**Bid 12-184, Addendum No. 1**

**December 14, 2012**

**Questions and Answers**

Figure 1 – Sample Network Block Diagram

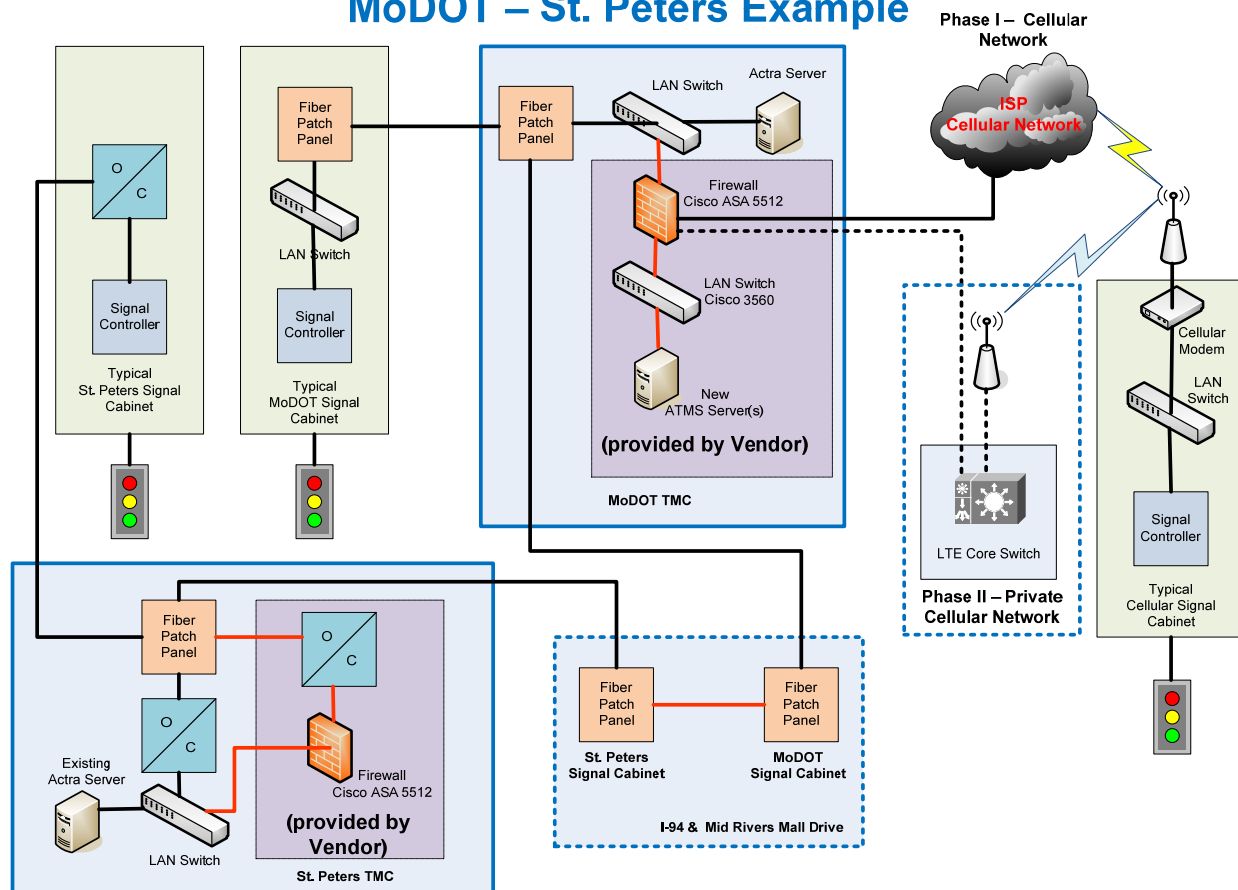
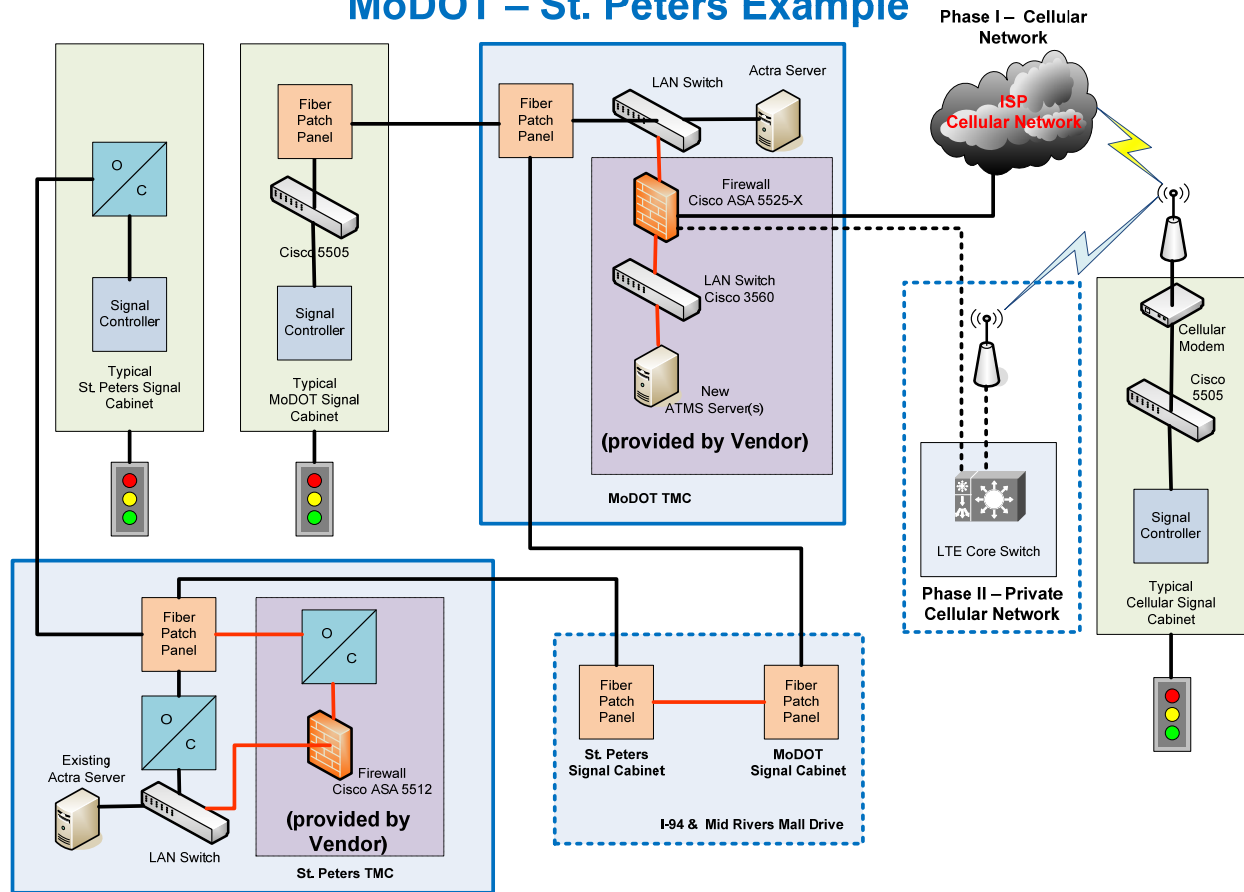
In the Job Special Provisions (JSP) for the Advanced Traffic Management System (ATMS), the Vendor is required to provide a LAN Switch as per Figure 1. The switch is described as a Cisco ASA 5512, see figure below from the JSP.

Addendum 1 modifies the LAN Switch requirement to change the Cisco ASA 5512 to a Cisco ASA 5525-X supporting a minimum of 3 Mbps throughput level. The change is driven by the need to support the full load of the field communications coming into the TMC. A description of the Cisco ASA 5525 is provided in the table below.

Vendors shall replace existing Architecture diagram with the following diagram. The replacement graphic is updated for the amended hardware requirement of a Cisco ASA 5525-X to replace the previously required Cisco ASA 5512.
